# Automotive Silicon Errata and Data Sheet Clarifications

## ATtiny3216/3217 Automotive

The ATtiny3216/3217 Automotive devices you have received conform functionally to the current device data sheet ([www.microchip.com/DS40002212](http://www.microchip.com/DS40002212)), except for the anomalies described in this document. The errata described in this document will likely be addressed in future revisions of the ATtiny3216/3217 Automotive devices.

**Figure 25-1. USART Block Diagram**

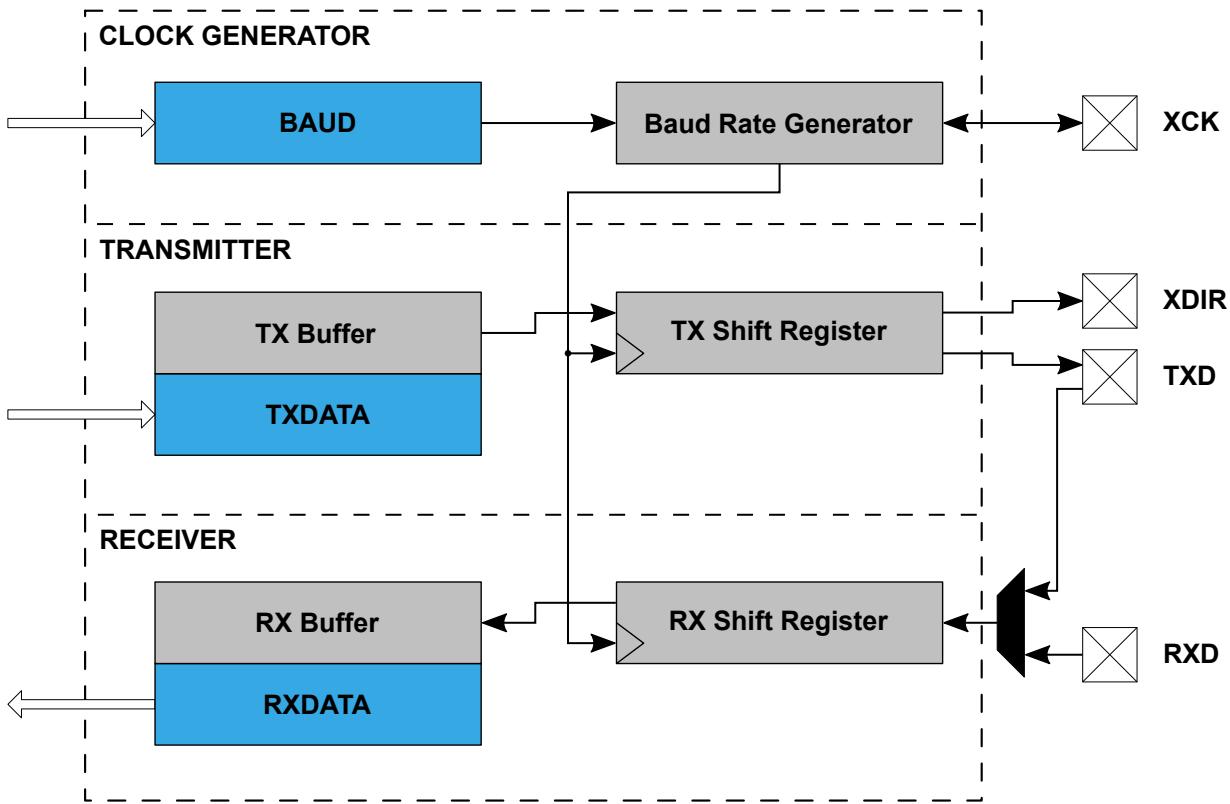
The block diagram is missing that USART TX is double-buffered from *Figure 25-1. USART Block Diagram* in the data sheet. The figure below shows the added **TX Buffer**.

The transmitter consists of a **two-level** write buffer.

The data transmission is initiated by loading the **Transmit Data (USARTn.TXDATAH and USARTn.TXDATAH)** registers with the data to be sent. The data in the **Transmit Data registers** are moved to the **TX Buffer** once emptied and then to the Shift register once it is empty and ready to send a new frame.

**Figure 3-1. Package Marking Information**

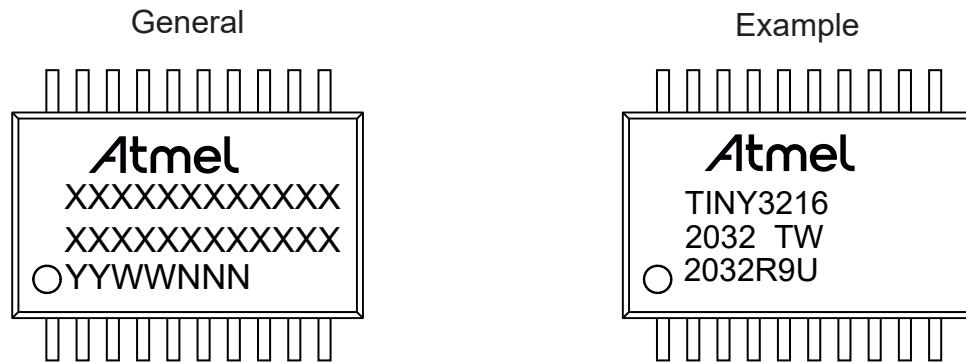
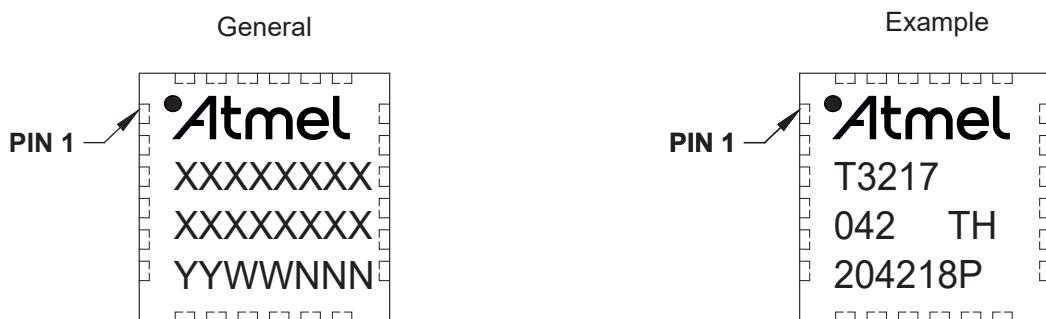
Package marking information is missing in the data sheet. This section contains all package marking information for ATtiny3216/3217 Automotive devices.
